18 WELL ROAD

I50226-WR

*AMENDED PROPOSED SINGLE STOREY REAR EXTENSION AND LINK*

**DESIGN & ACCESS STATEMENT | ADDENDUM | REV P2**

FIGURE4. BASEMENT CONNECTION LINK OPTION 01

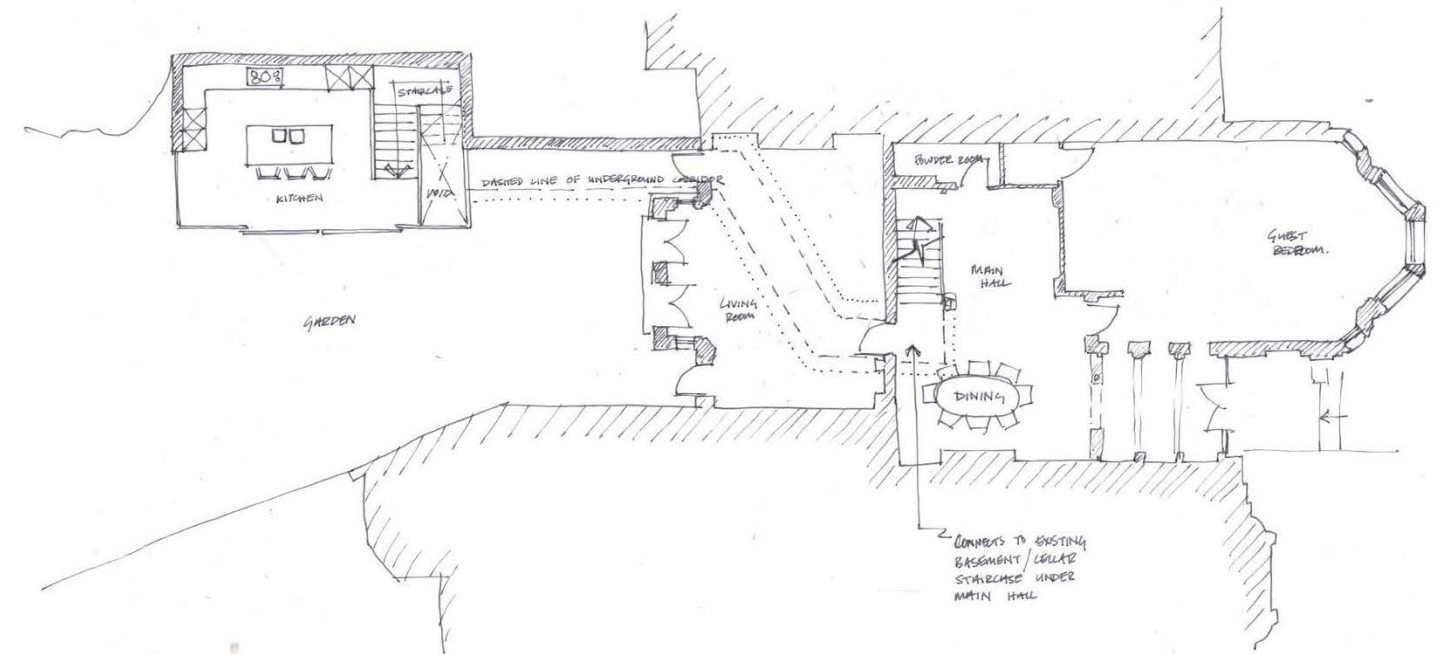
2.2.1 The design team presented sketches to illustrate exploration of options to create a subterranean connection between the existing house and the proposed garden 'pavilion' extension. The principles of such a design were discussed, and it was agreed that this would not be a viable solution in view of the complexities outlined below:

- Constraints of restricted access to the 'landlocked' rear garden.
- Technical difficulties and risks associated with temporary support of the existing historic rear elevation of the house to create subterranean space.
- Impact to the internal layout of the existing house to incorporate a staircase leading to a subterranean link.
- Impact on adjoining properties.

2.2.2 It was concluded due to the foregoing issues that a subterranean connection between the main house and proposed garden 'pavilion' extension would not represent a viable option to overcome the Council's concerns, and would in fact result in greater impact and harm to the historic fabric of the property.

FIGURE8. SOUTH ELEVATION  
AMENDED PROPOSED EXTENSION AND LINK

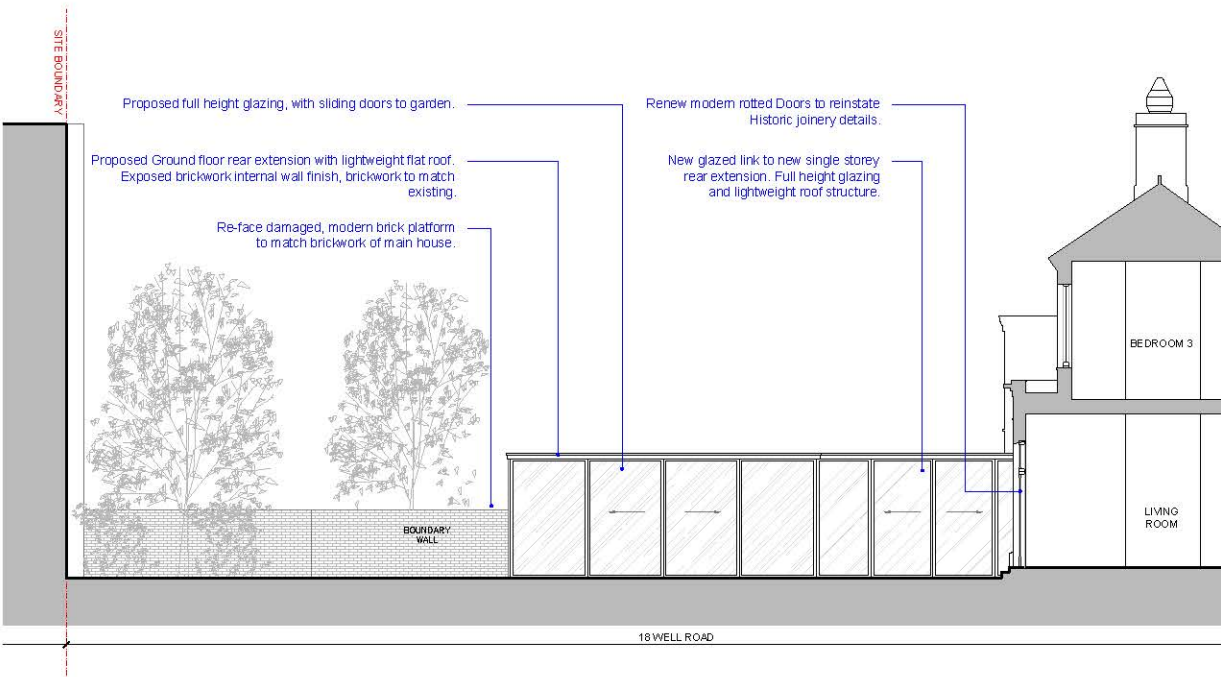
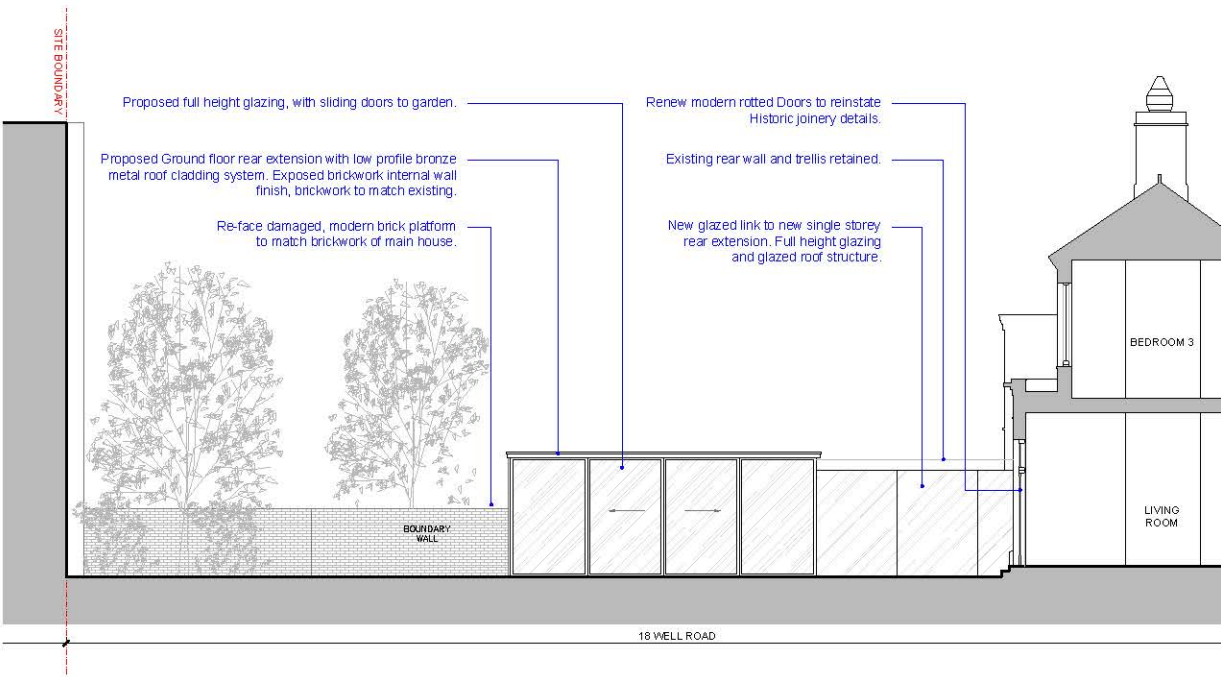
- 3.1.1 The proposed amendment to the glazed link reduces it's height in relation to the garden 'pavilion' extension, to create a lower roof to this element of the scheme, resulting in a more subservient structure which is expressed as a transitional space between the main house and proposed kitchen area, rather than as part of the larger and taller structure.

- 3.1.2 The reduced height link element is now consistent with the transom between the adjacent French doors and fanlight windows to the rear elevation of the main house.

- 3.1.3 The width of the link element remains as narrow as possible while encompassing the proposed new single door opening in the rear elevation of the main house. The roof profile of the link has been amended to fall away from its glazed elevation, to eliminate any need for a projecting overhang.

FIGURE 15. AMENDED PROPOSED LANDSCAPE SCHEME

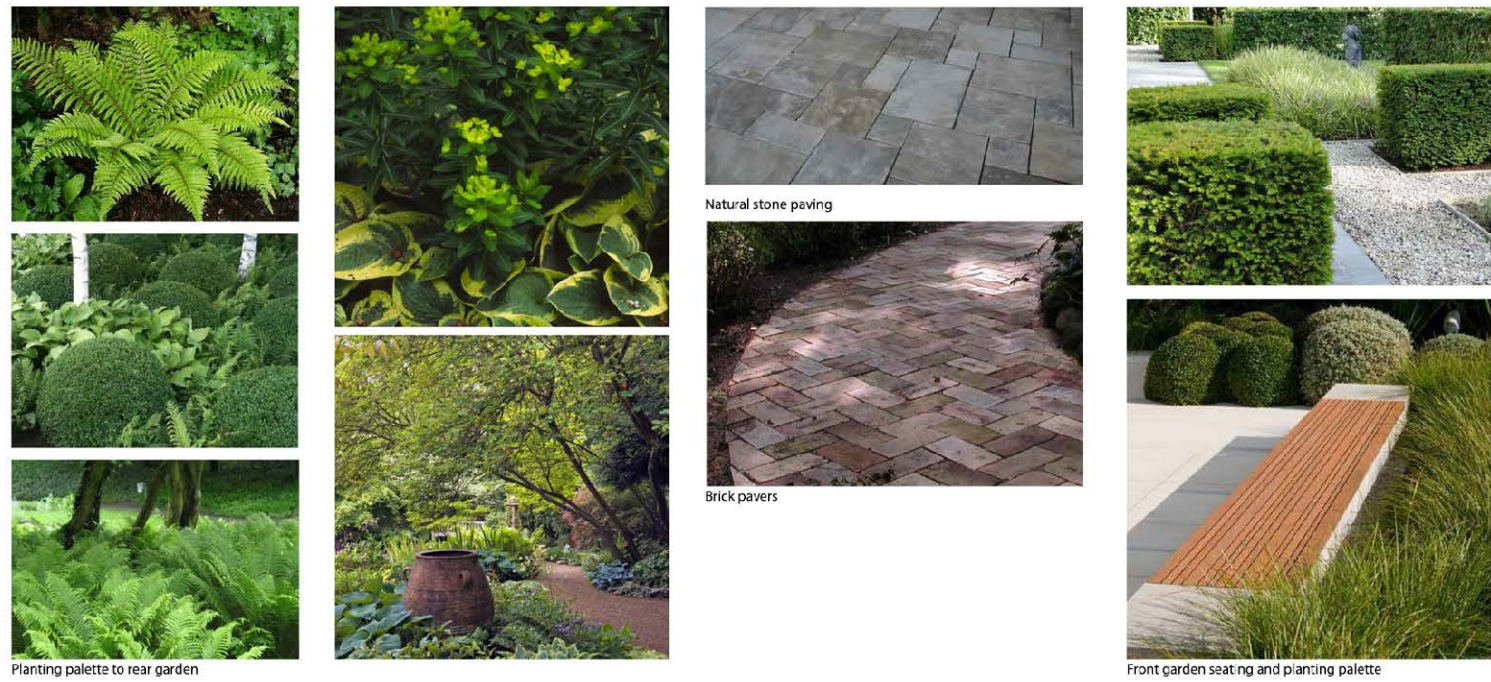
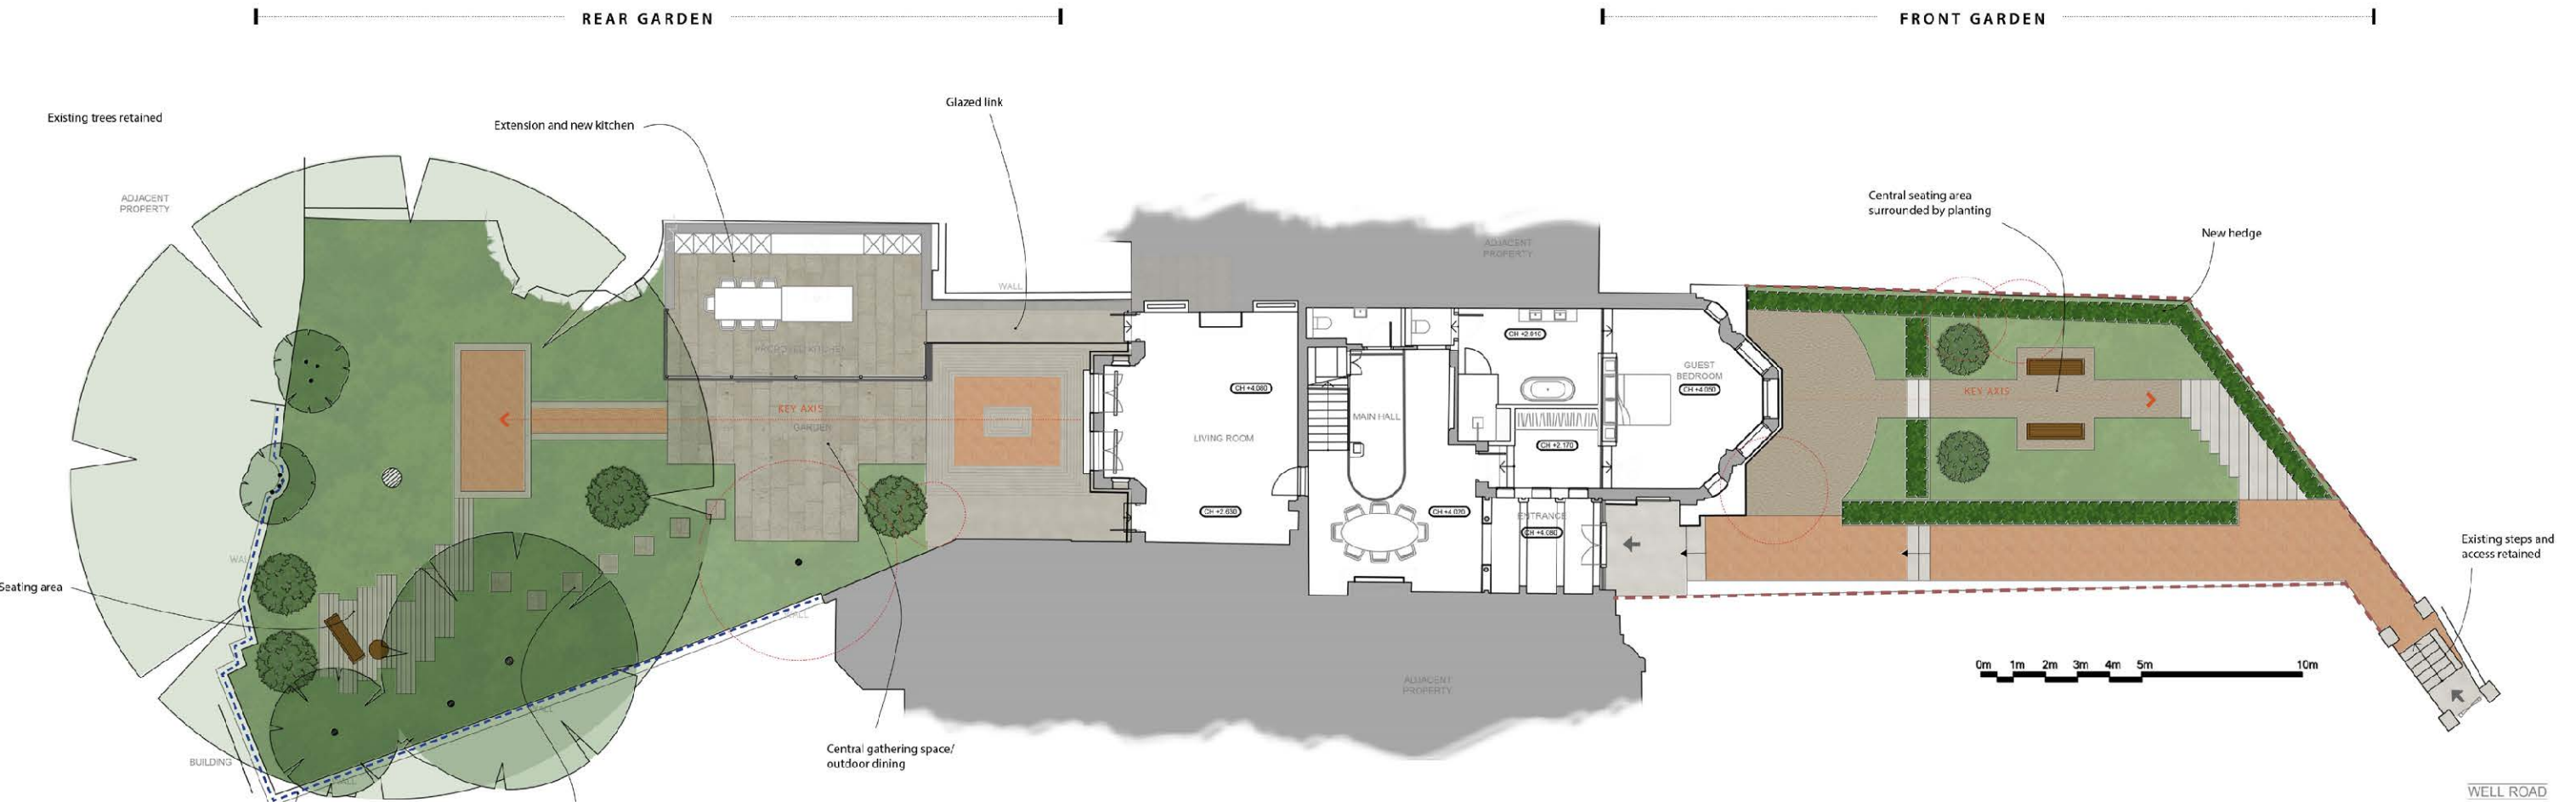
- 3.1.4 Pergola:  
In response to Officers' comments, the originally proposed pergola structure has been omitted from the scheme, as this was not considered to create a sense of symmetry to the rear elevation. Refer to amended landscape scheme (Figure 15).
